Technical Service BULLETIN

'P' or 'N' to 'R' DELAYED ENGAGEMENT

Tacoma, 4Runner, T100, Land Cruiser

TC002-97

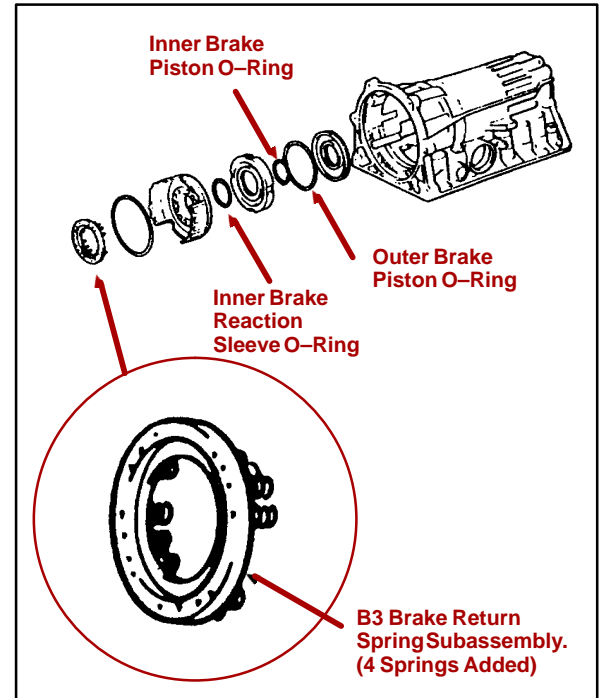
1. Springs were added to B3 Brake Return Spring Subassembly.

PREVIOUS	NEW
Number of Springs	16	20
